Chapter 11 Radioactive Waste Management

This section of the referenced DCD is incorporated by reference with the following departures and/or supplements.

Figure 11.4-1R Solid Waste Management System Process Diagram

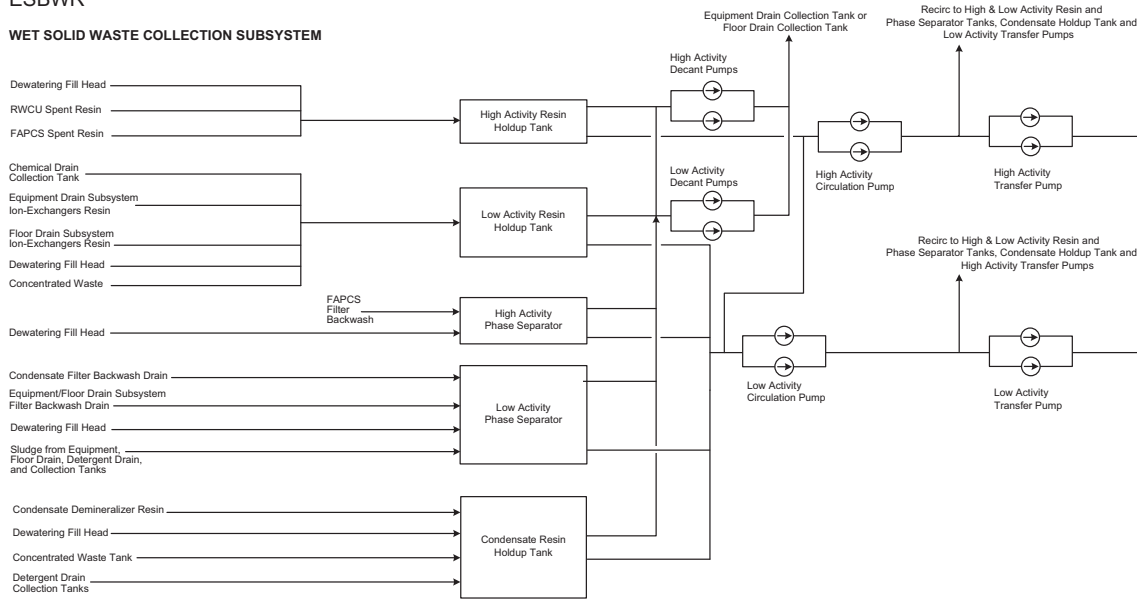
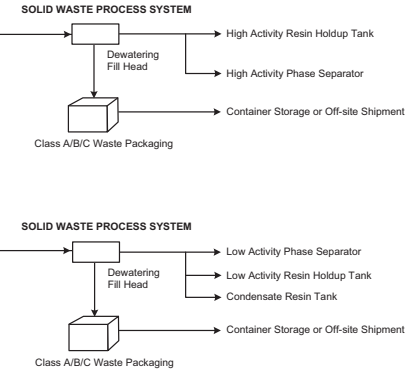
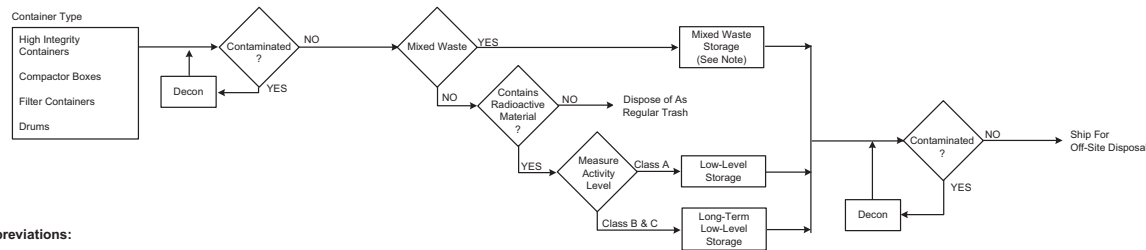
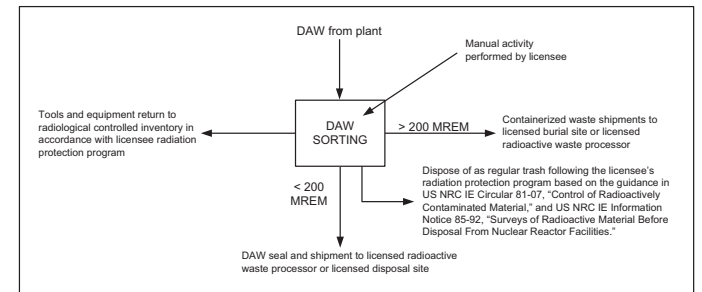
Replace text references to DCD Table 11.4-1, Table 11.4-2, Figure 11.4-1, and Figure 11.4-2 with [Table 11.4-1R](#), [Table 11.4-2R](#), [Figure 11.4-1R](#), and [Figure 11.4-2R](#), respectively.

See [Figure 1.2-23R](#) and [Figure 11.4-1R](#) for container storage schemes and sequencing.
